REMARKS

VERSION WITH MARKINGS TO SHOW CHANGES MADE

Fig. 1

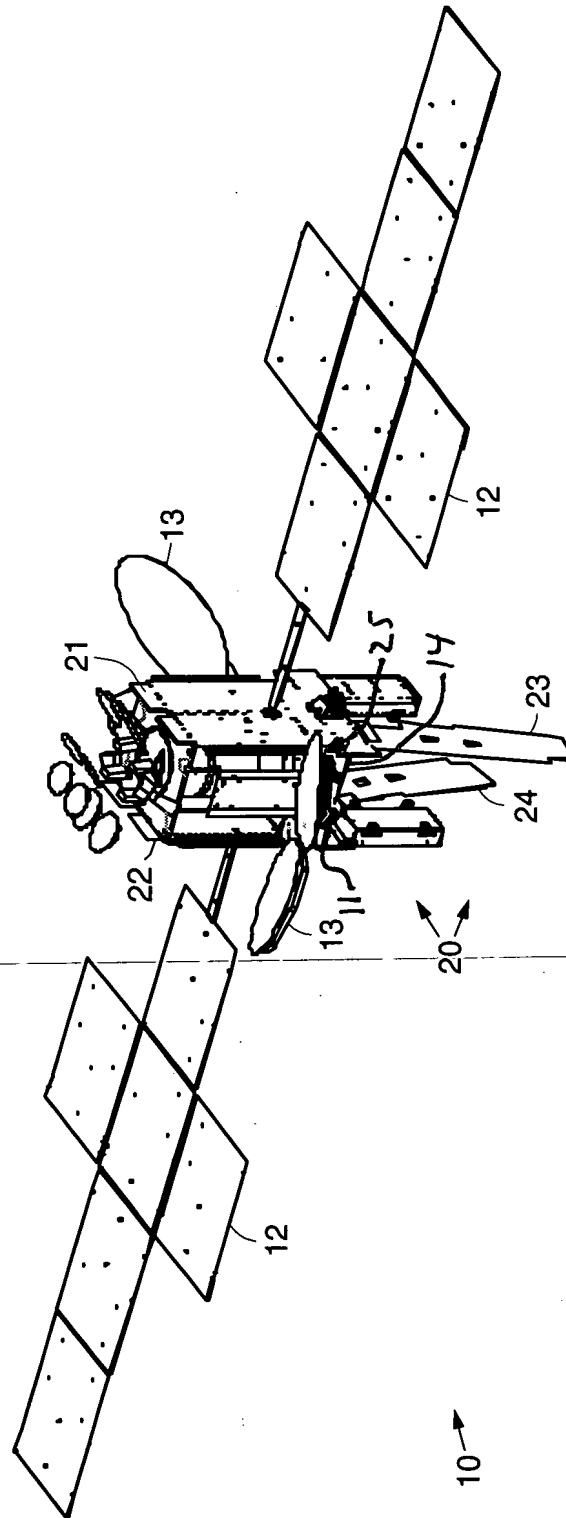
Figure 1 of the drawings was objected to because "a body 11" and "a south facing radiator 22" are recited in the specifications but are not shown on figure 1. Fig. 1 has been amended to add reference numeral "11" thereto. However, reference numeral "22" is shown in Fig. 1 at the upper left side of the spacecraft body. Figs. 2 and 3 have been amended to include reference numeral "11". Enclosed herewith are amended drawing figures containing proposed amendments marked in red ink. Also enclosed is a set of replacement reproducing masters having the amendments included therein. Entry of the amended drawings and replacement reproducing masters is respectfully requested.

Figures 1-3 were objected to because "aft deck 14" is recited in the specification but is not shown on the figures. Reference numeral "14" designating the "aft deck" has been added to Figs. 1-3 along with reference numeral "25" generally designating the "one or more coupling or loop heat pipes 25".
